Date: 14th October 1996

## EVENT PLUS KEYPAD FLASH

View From Solder Side

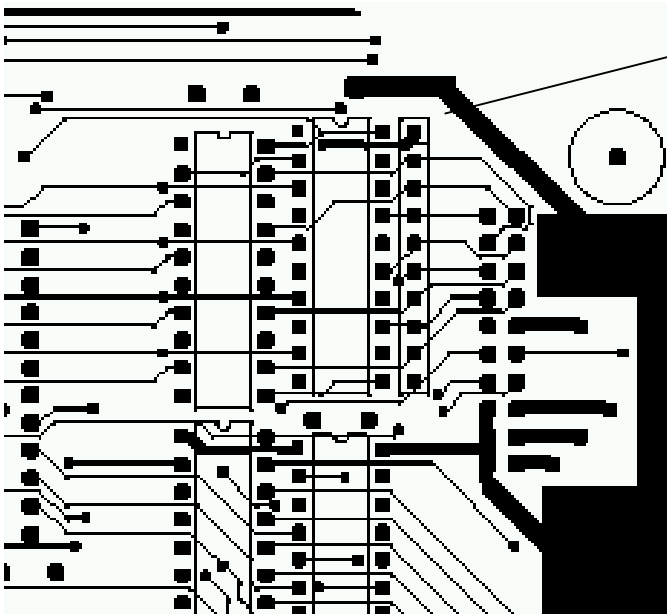
Under certain conditions the LEDs in the keypad buttons of the Event Plus console momentarily flash. This appears at random and has no adverse effect on the console operation, however it can be a distraction to the user. To fix this the CPU card needs to be modified as follows:

1. Remove CPU card.
2. Locate RS5 located between CN2 and IC14.
3. Cut track leading to pin 1 of RS5.
4. Link pin 1 RS5 to thick ground track nearby.
